ADDENDUM NUMBER ONE 10/26/2018

PROJECT: TOWN OF POMARIA RECERATION RENOVATIONS – 3606.1704
138 FOLK ST.
POMARIA, SC 29126

FROM: Johnson, Laschober & Associates, P.C.
1296 Broad Street
Augusta, GA 30903
(706) 724-5756

DRAWING NO. **A-100** REV. **1**

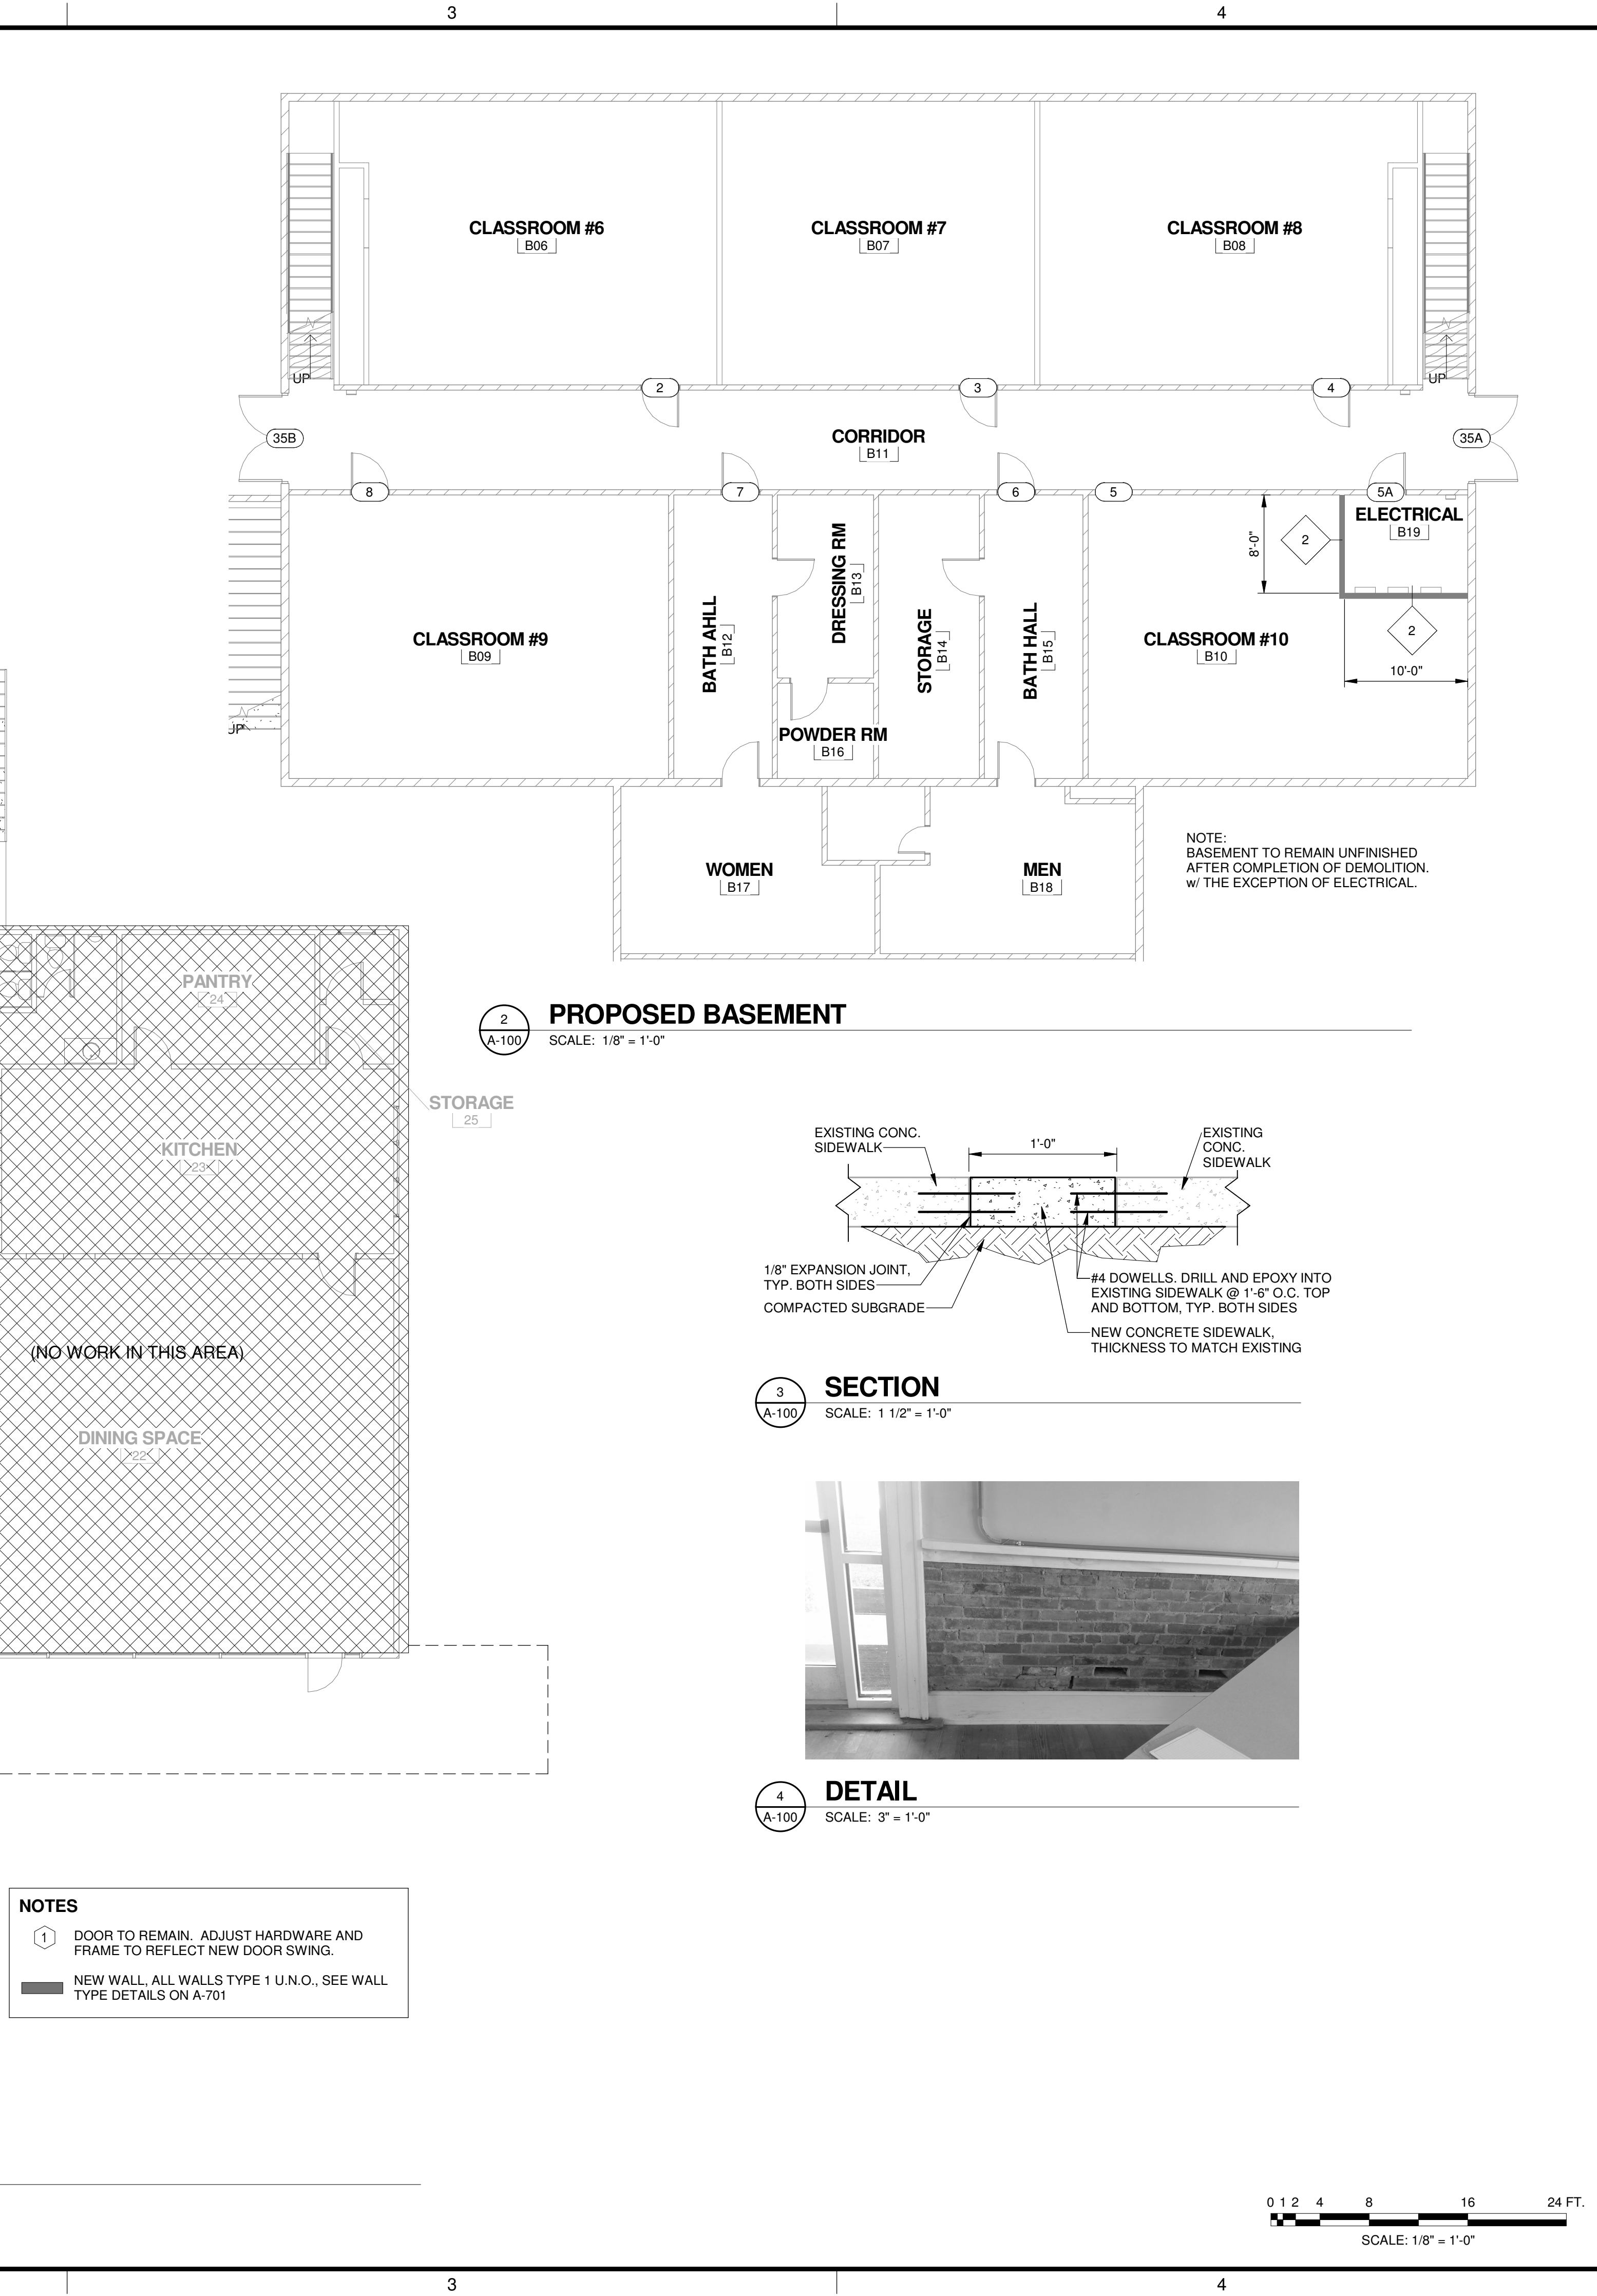
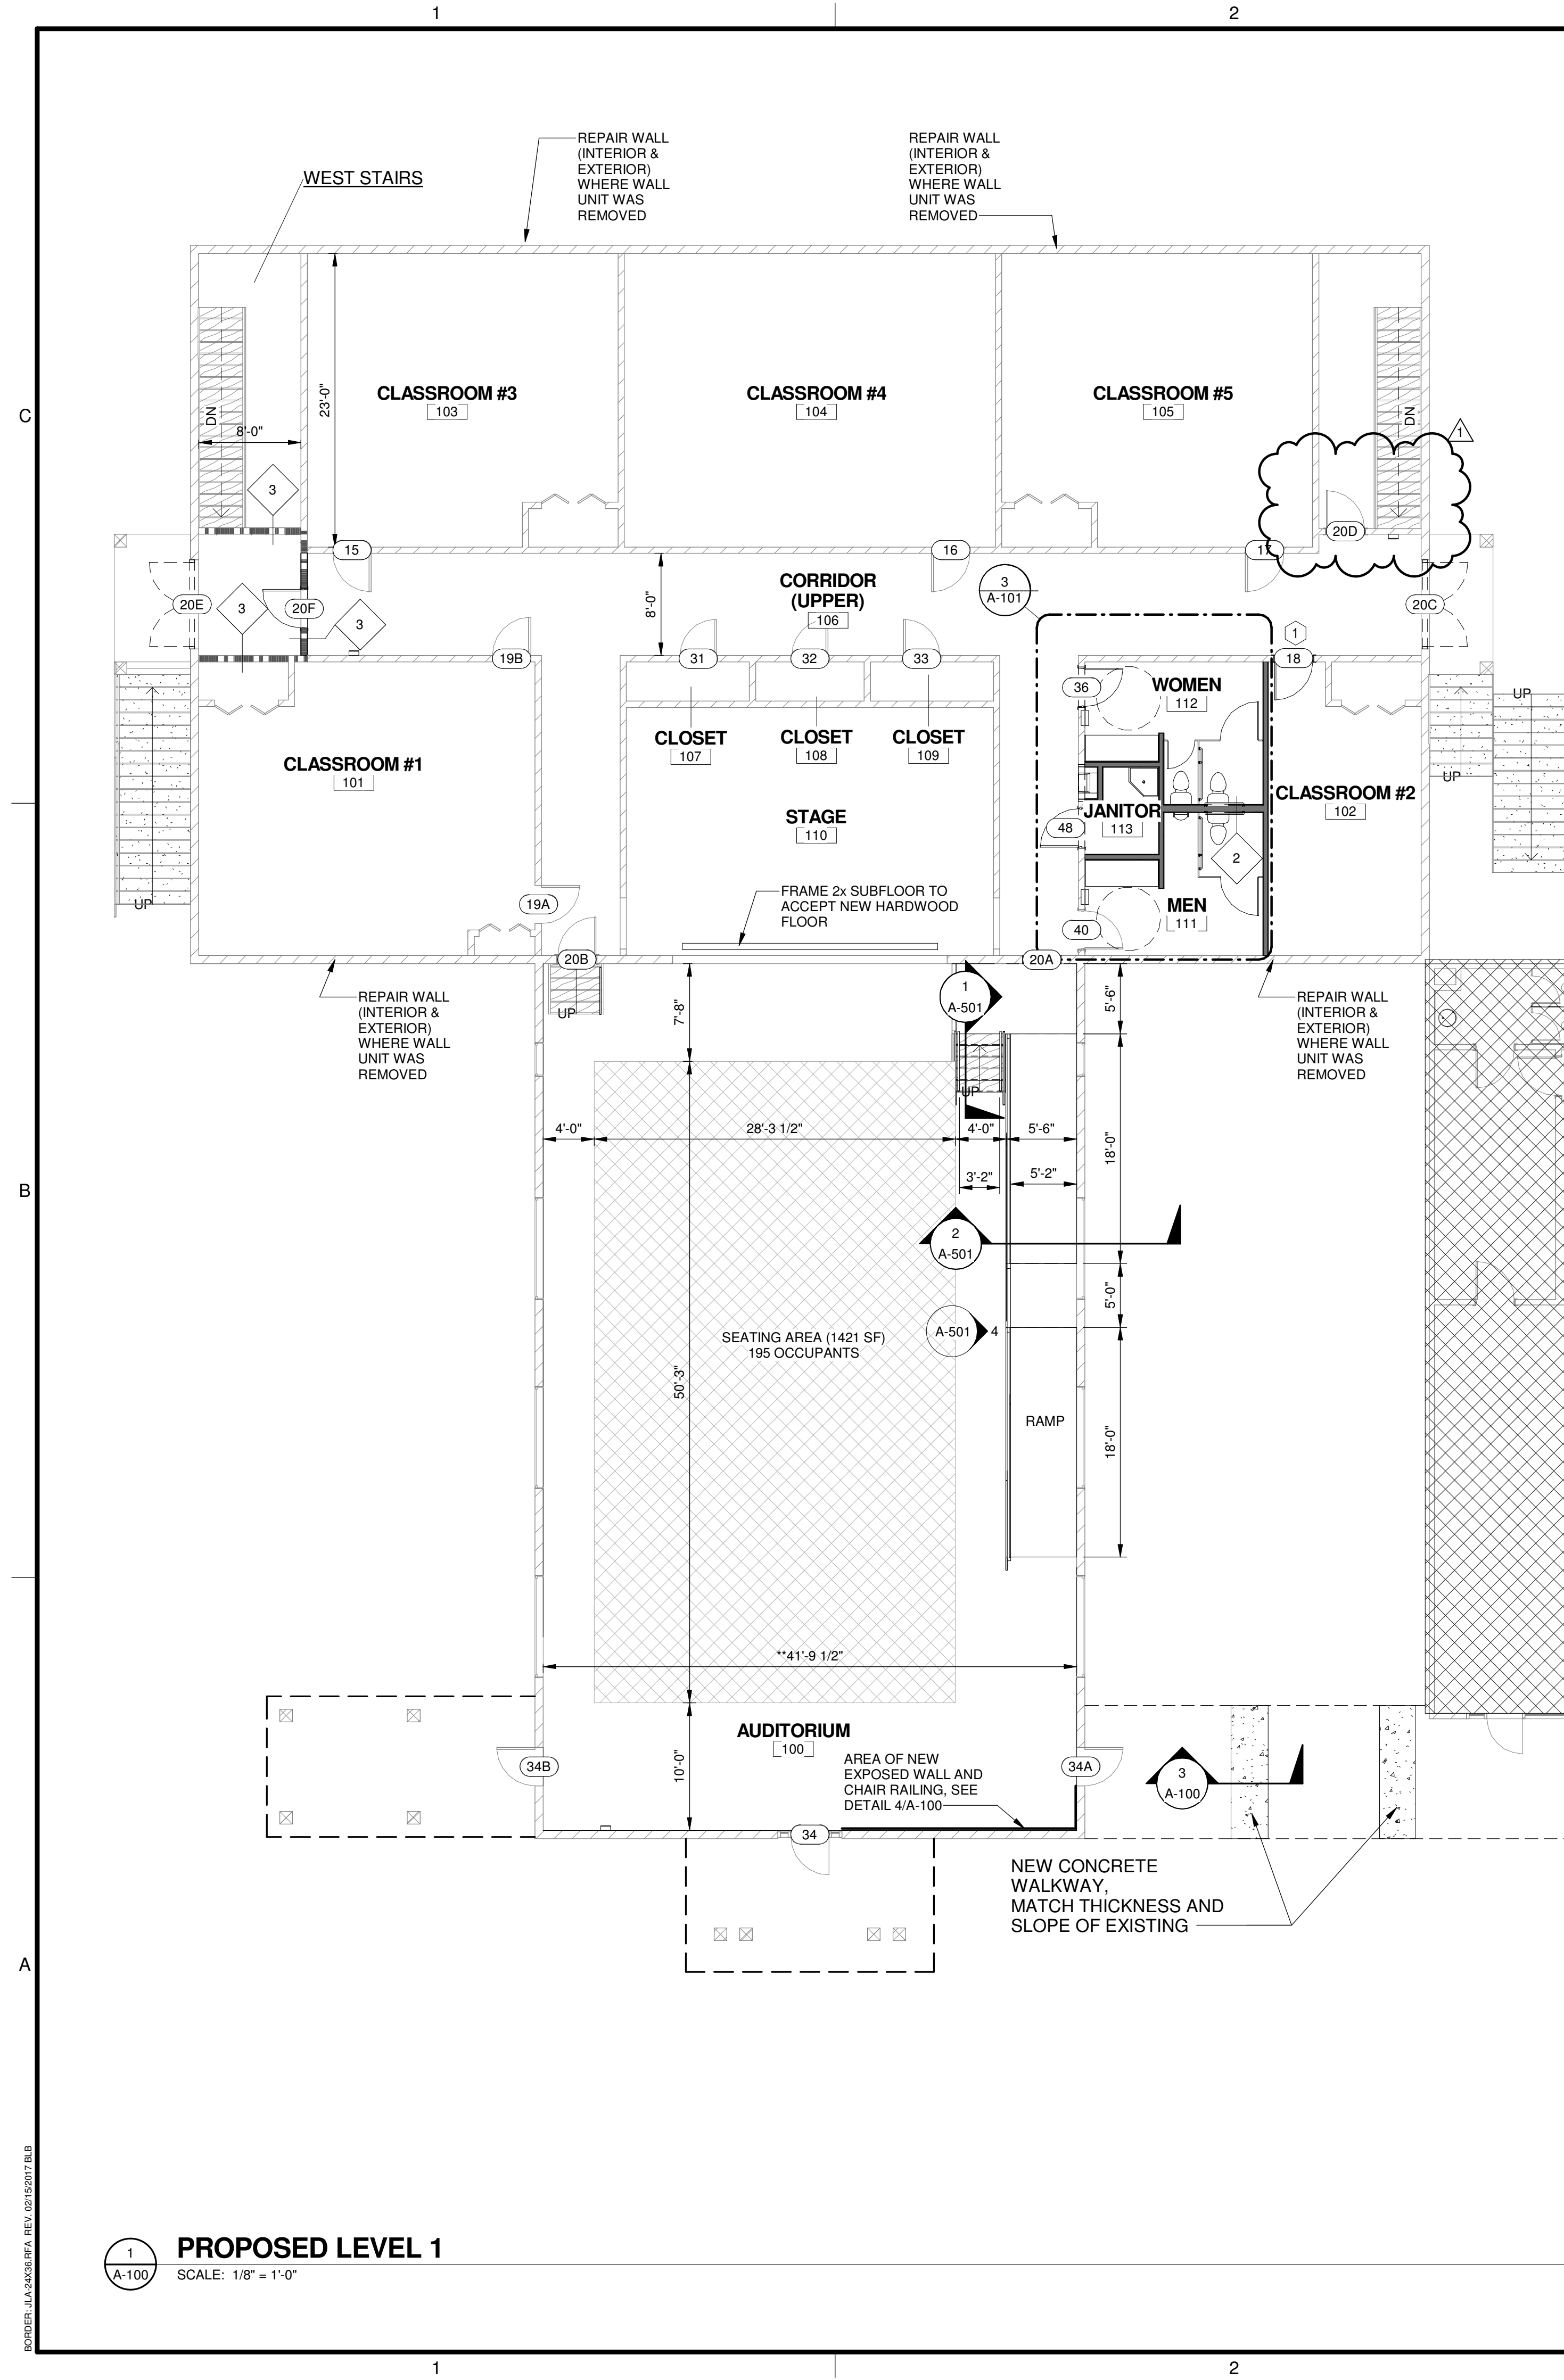
9. The **Door Schedule** has been updated to reflect doors shown on the proposed plan. See drawings A-100 and A-701 for changes.
10. Timeframe for **Standing Seam Metal** substitutions to be submitted has been updated to **5 days before** the bid date. Specification 074113, "Standing Seam Roof Panel" has been updated to reflect this.
